**Emmett Property Pty Ltd C/- Phillip Brunning & Associates**

**98-100 (A500) North Terrace, Adelaide**

DA 020/A040/18

## **ASSESSMENT REPORT**

**Figure 6 – Waste vehicle collection manoeuvres**

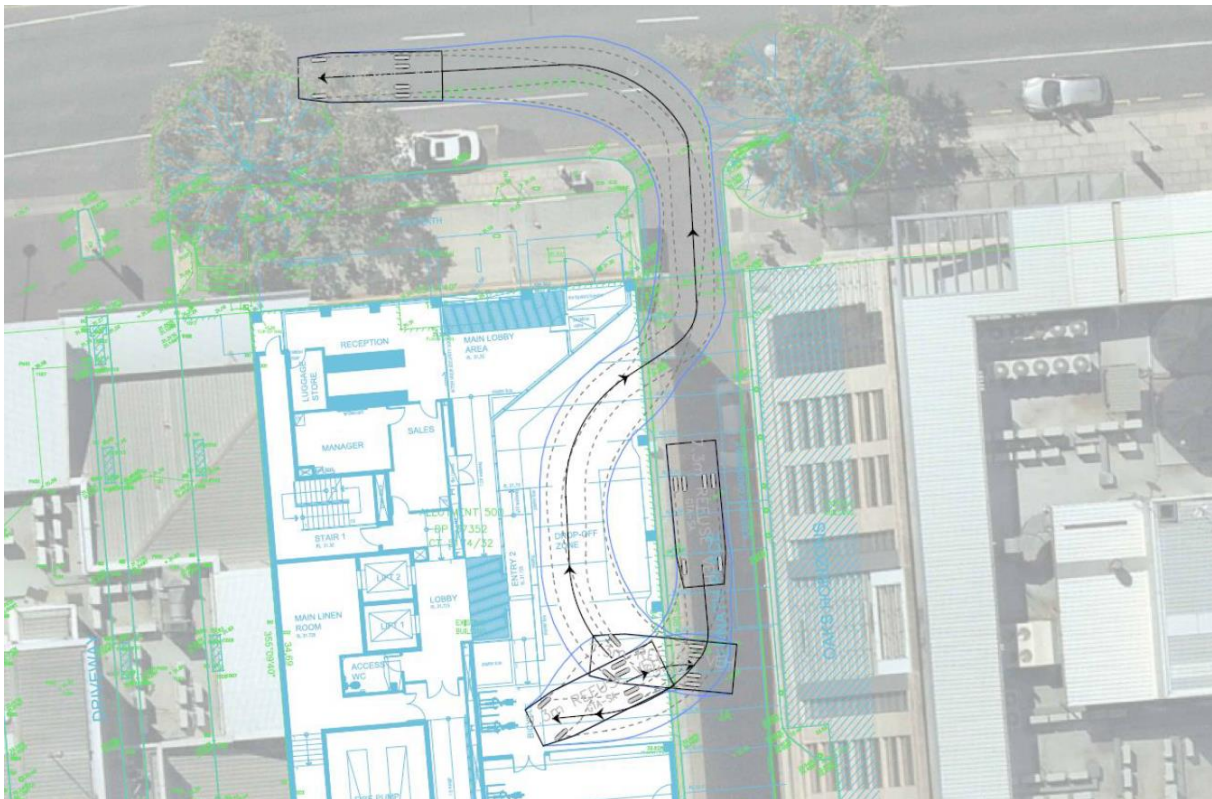
Whilst this manoeuvre is not ideal given the potential conflict with other vehicles entering the porte cochère, the manoeuvre is anticipated to occur outside of peak

Overall, whilst there are some reservations in relation to the refuse vehicle turn paths (causing conflict with drop off and pick up traffic movements from North Terrace), it has been demonstrated that it is possible to achieve appropriate vehicular movements to a sufficient degree that the proposal is considered to generally satisfy Development Plan requirements in relation to site access and vehicle parking.

### Planning Query 2:

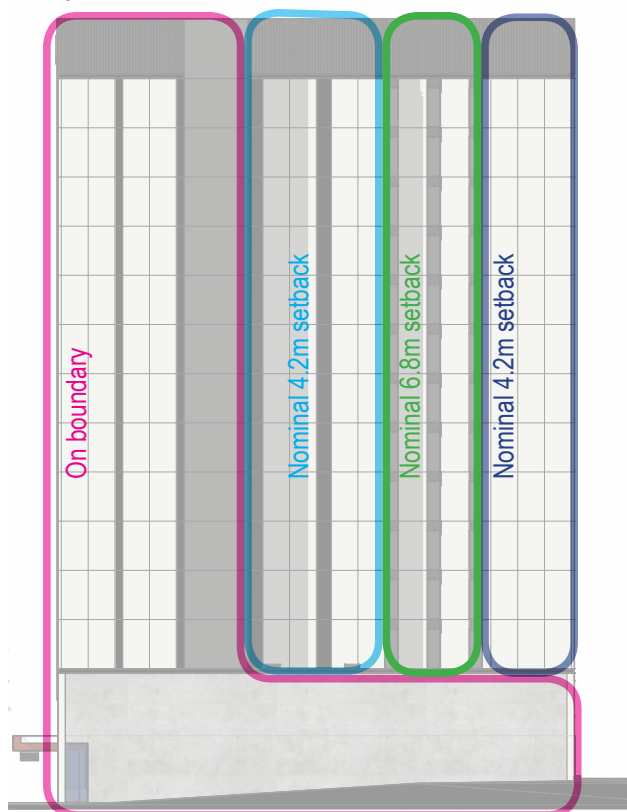
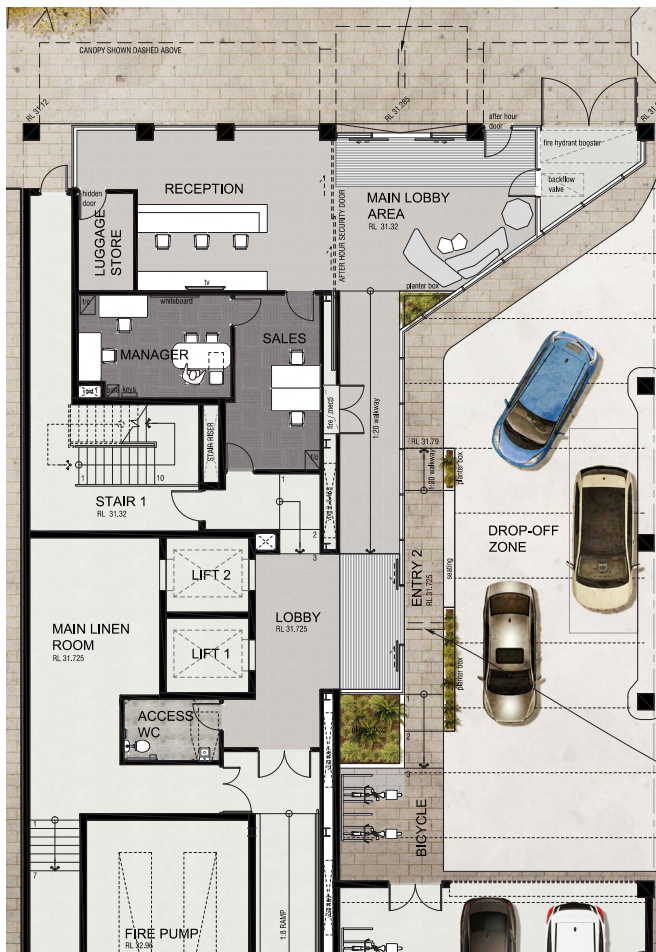
Further consideration of the articulation of the west elevation, with a view to achieving greater visual interest when viewed from the adjoining development.

Following receipt of the comments provided we have reviewed the design of the western facade and we have made design adjustments which we believe strike the right balance. Please refer to our amended external elevations.

First Floor Level

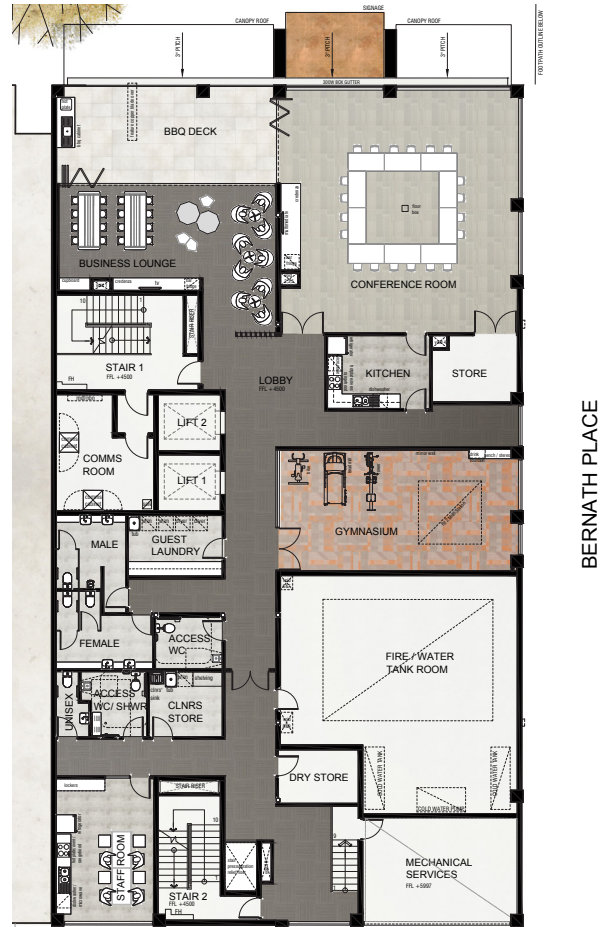
- Further consideration of level one internal planning, including the location of the conference room kitchen, and light access to staff and corridor spaces; and

We have adjusted the first floor plan arrangement to provide opportunities for windows into the circulation spaces and staff areas. We believe this will greatly improve the occupant experience.

Please refer to our adjusted first floor plan.

GROUND FLOOR PLAN  
18003 SK113A 08/08/18 A1 DRAWN\_K.L

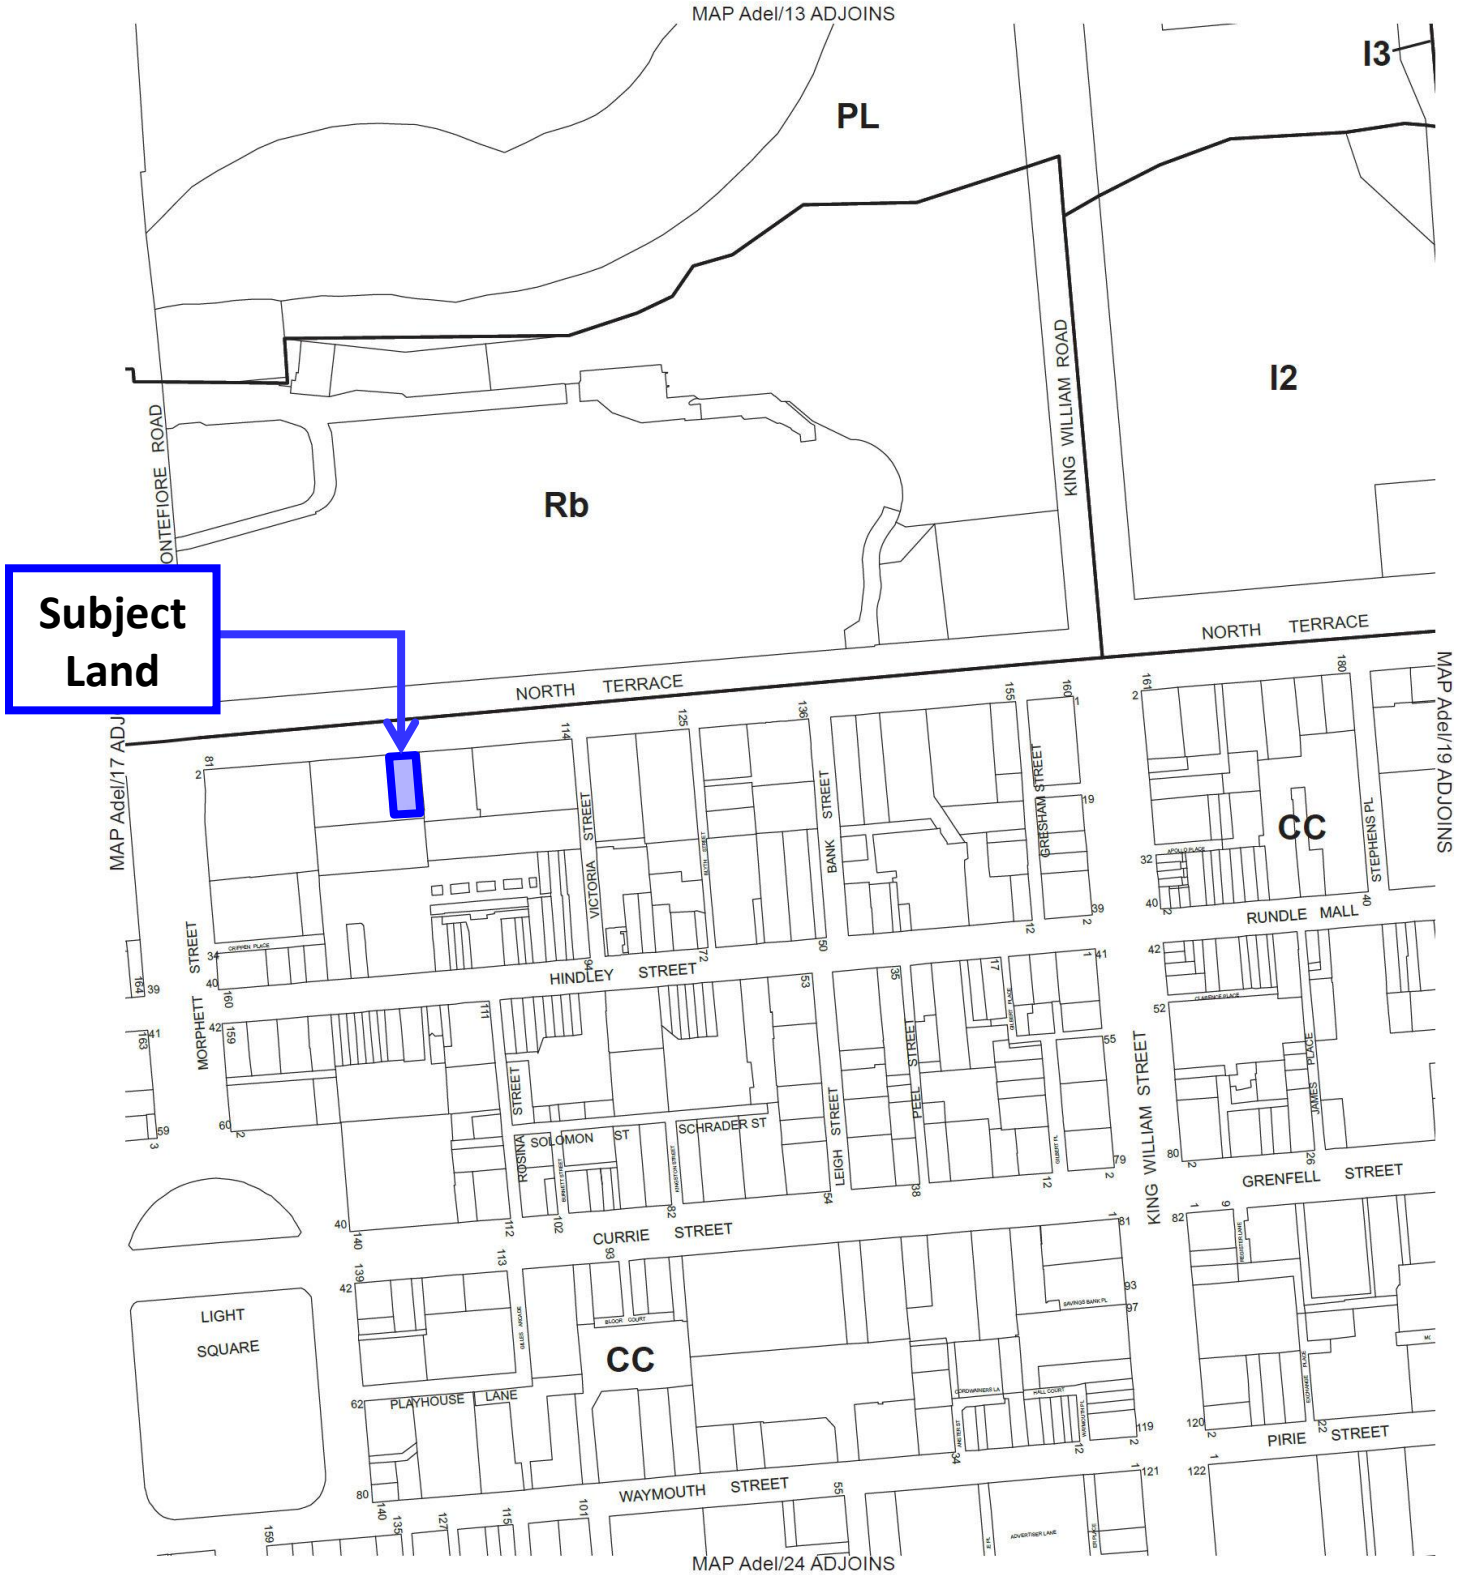
*Further consideration of the ground floor internal planning and the car parking strategy, with a view to creating greater visual and physical connectivity between the two lobby spaces, and to maximise activation of Bernath Place.*
